APPROVAL STAMP:
Vermont Agency of Transportation
RECEIVED
CK'D BY JDG/SMC OK'D BY WDL
April 18, 2016
RESUBMIT NO Approved AsNoted
BY RSY DATE 04/26/2016

TOWN OF CRAFTSBURY
ROUTE NO. TH-4, RURAL MINOR COLLECTOR
BRIDGE NO.: 4 PROJECT NO.: BO 1449(34)

COVER SHEET

PREFABRICATED BRIDGE UNIT DETAILS "CR-PBU1"

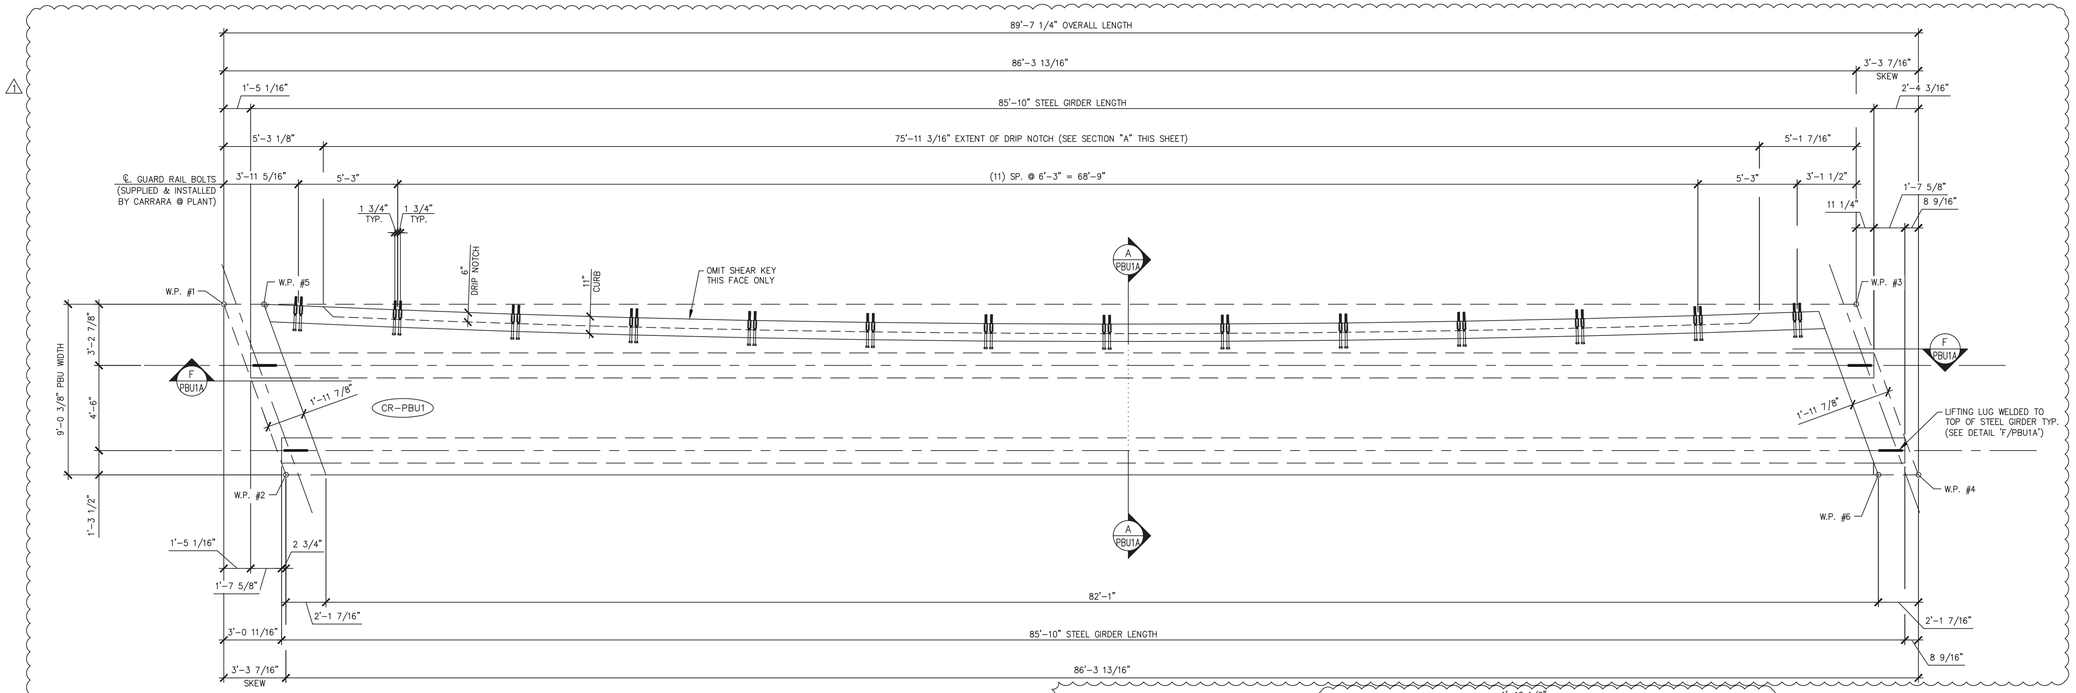
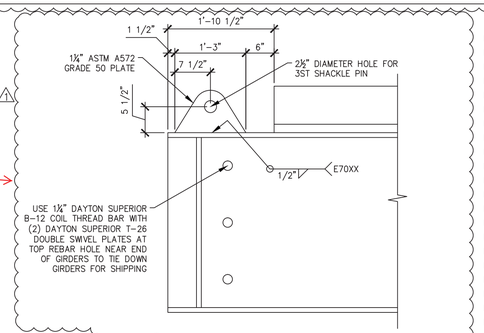
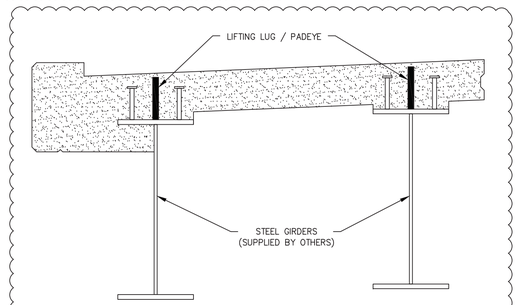
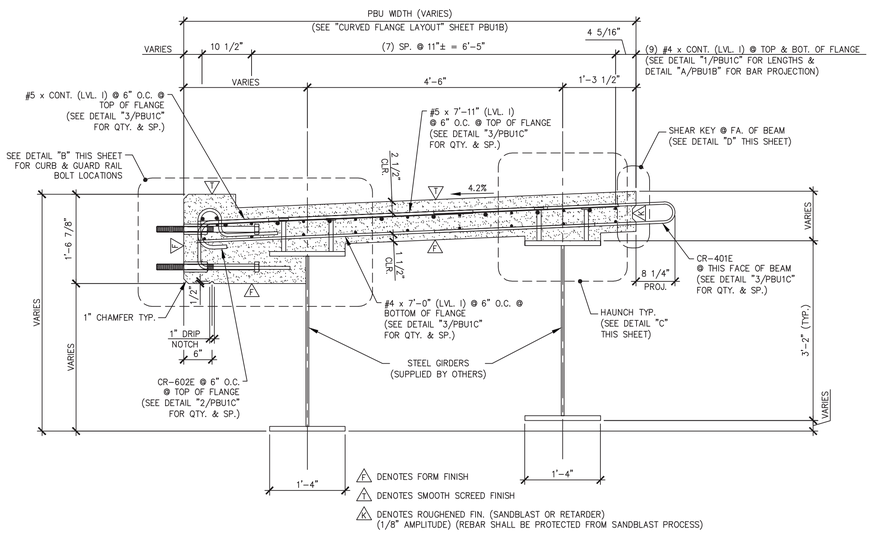
We are waiting for the Structural Steel re-submittal and associated welding procedures.

2 PBU1C REINFORCING PLAN VIEW IN FORM (FOR CURB BARS)

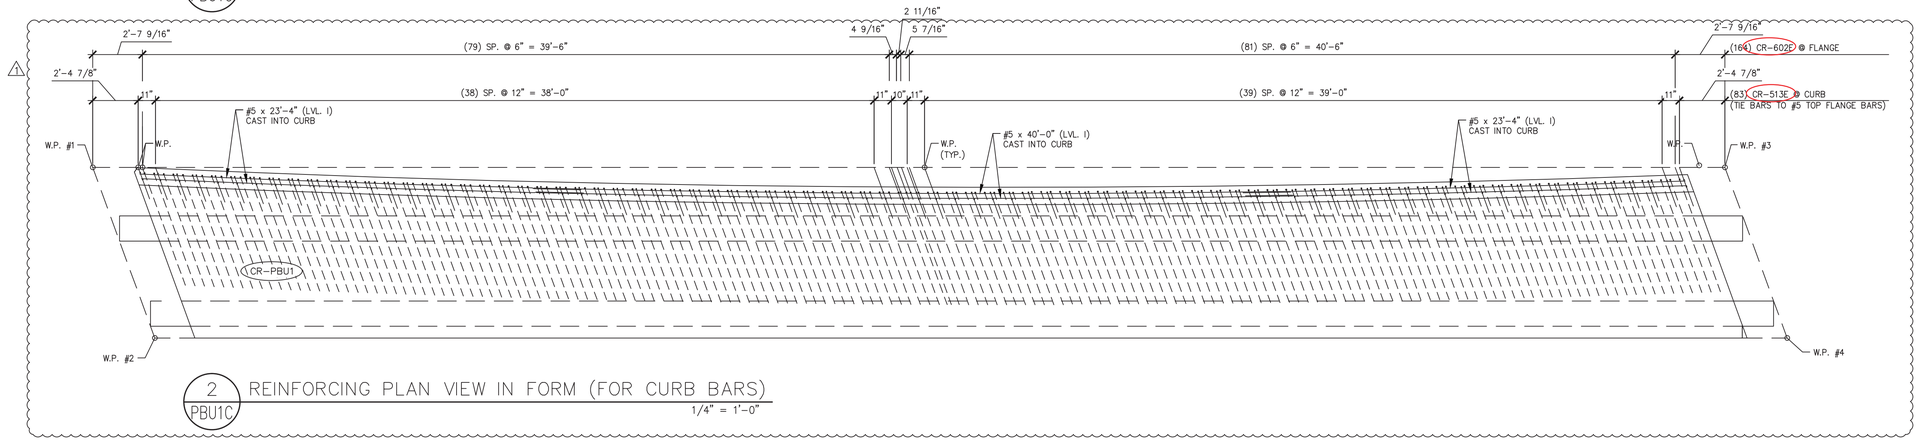
Bars 602E and 513E not found on sheet M2

1 PBU2B REINFORCING PLAN VIEW IN FORM

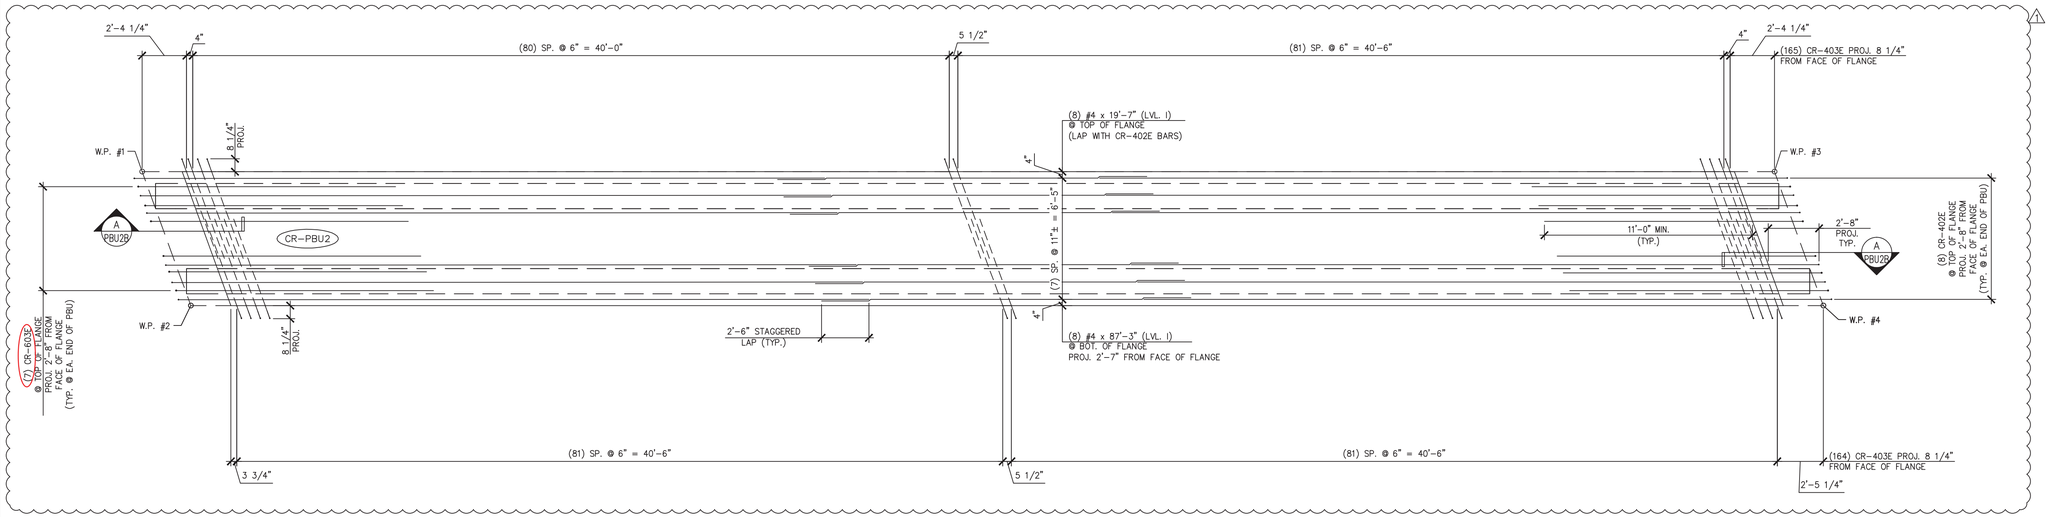
Bar 603E not found on sheet M2

1 PBU3B CURVED FLANGE LAYOUT
1/4" = 1'-0"

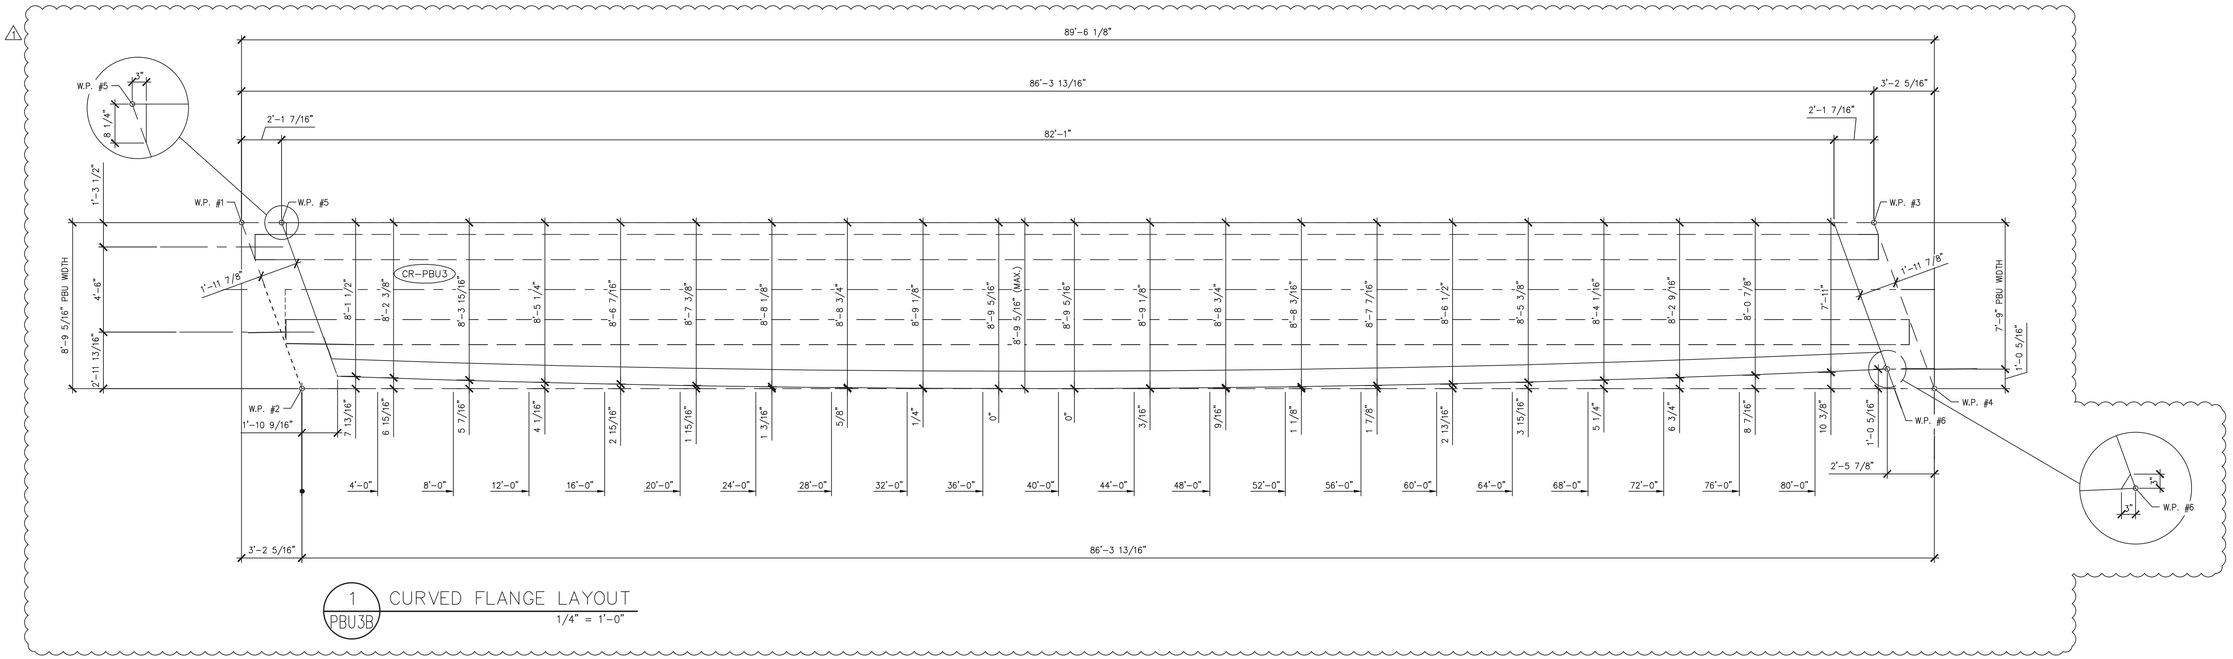
Bar 603E not found on sheet M2

1 PBU3C REINFORCING PLAN VIEW IN FORM (FOR LONGITUDINAL BARS)
1/4" = 1'-0"

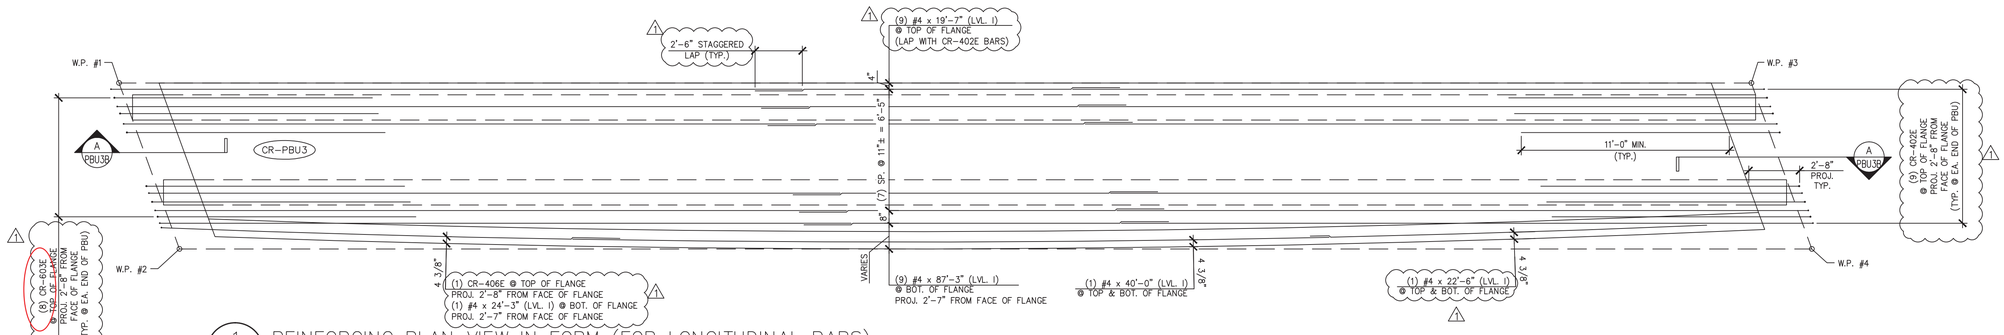
Bars 602E, 603E, and 516E are not found on sheet M2
